**RE: Lot 11 Block 6 Unit 17 Volcano Cliffs SAD 228
6532 Kimmick NW
Grading and Drainage Plan
Engineers Stamp Date 10/28/19 (D10D003M11)
Pad Certification Date 3/24/2021**

Based upon the information provided in your submittal received 8/17/2021, this plan cannot be approved for Building Permit until the following comments are addressed.

ENGINEER'S SEAL 	6532 KIMMICK	DRAWN BY WCMJ
	GRADING AND DRAINAGE PLAN	DATE 3-22-21
 <i>Rio Grande</i> <i>Engineering</i> 1606 CENTRAL AVENUE SE SUITE 201 ALBUQUERQUE, NM 87106 (505) 872-0889		210210029-LAYOUT-3-22-21 SHEET # —
DAVID SOULE P.E. #14522	3/24/21	JOB # 21021029

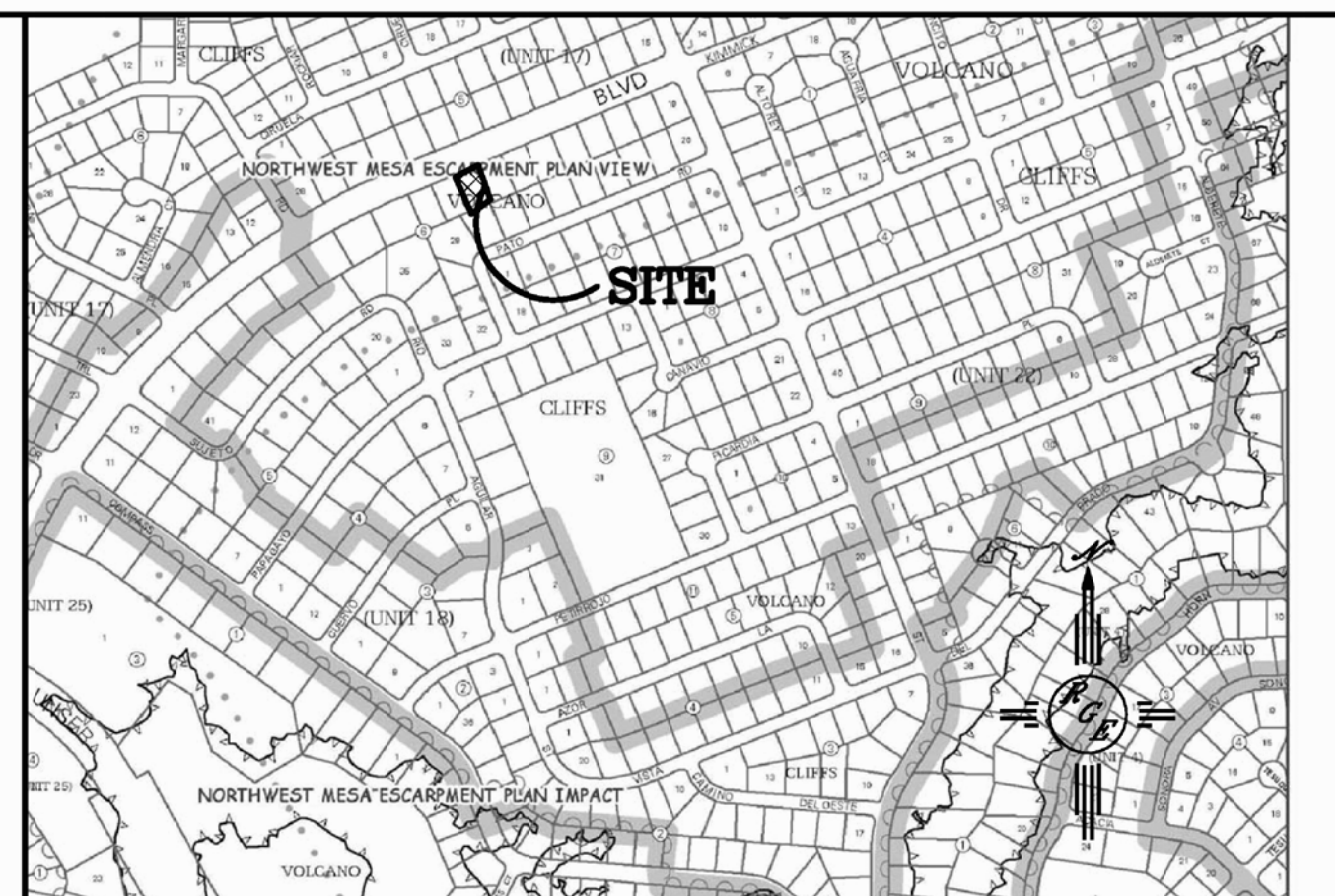
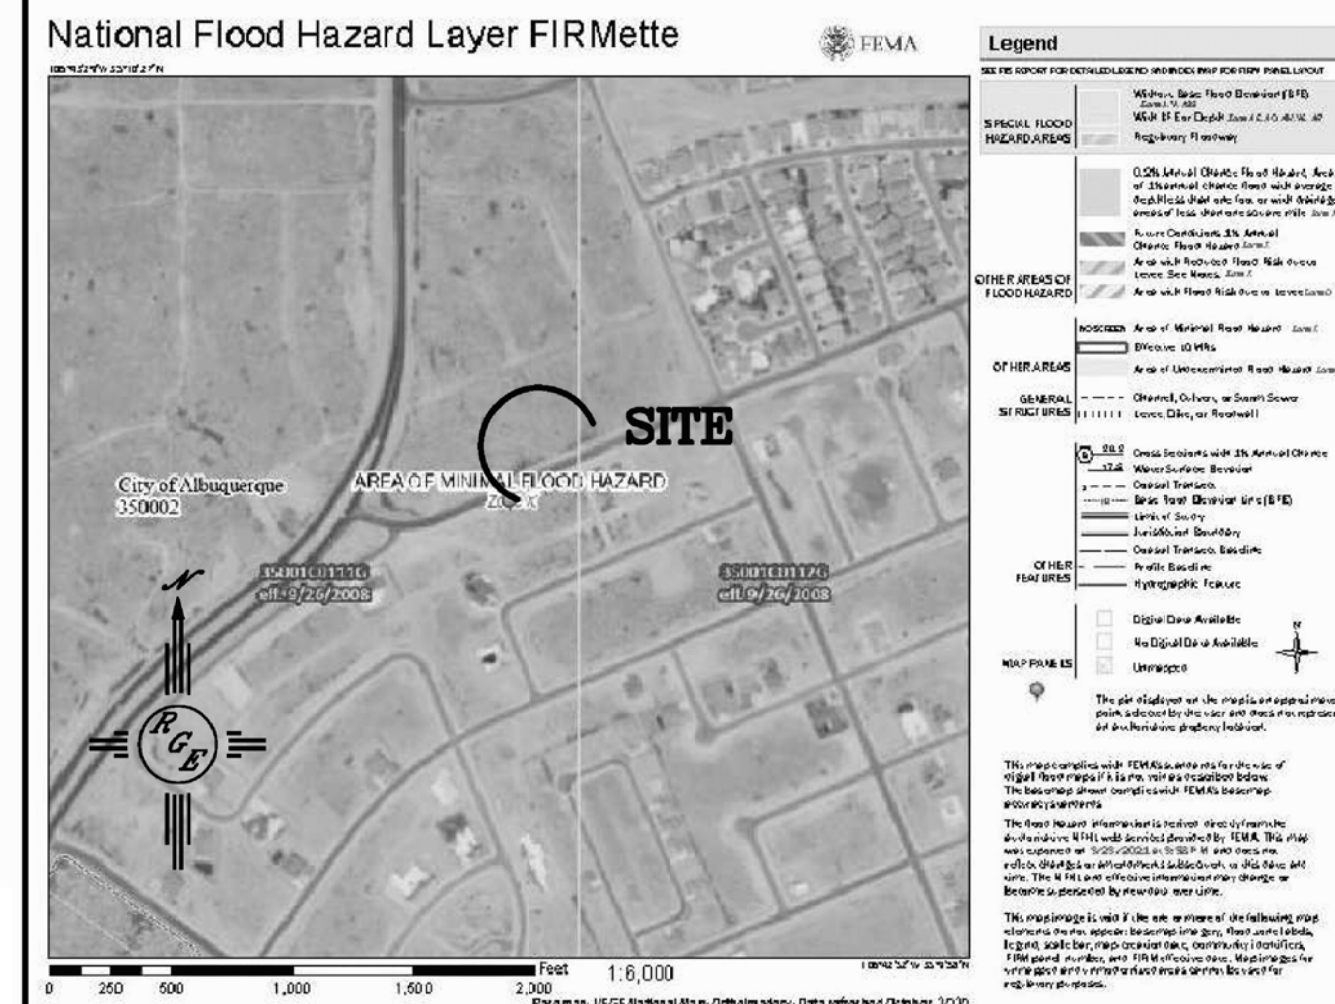
- Provide erosion protection for the building pad. The building pad is too high and the slope is too steep.
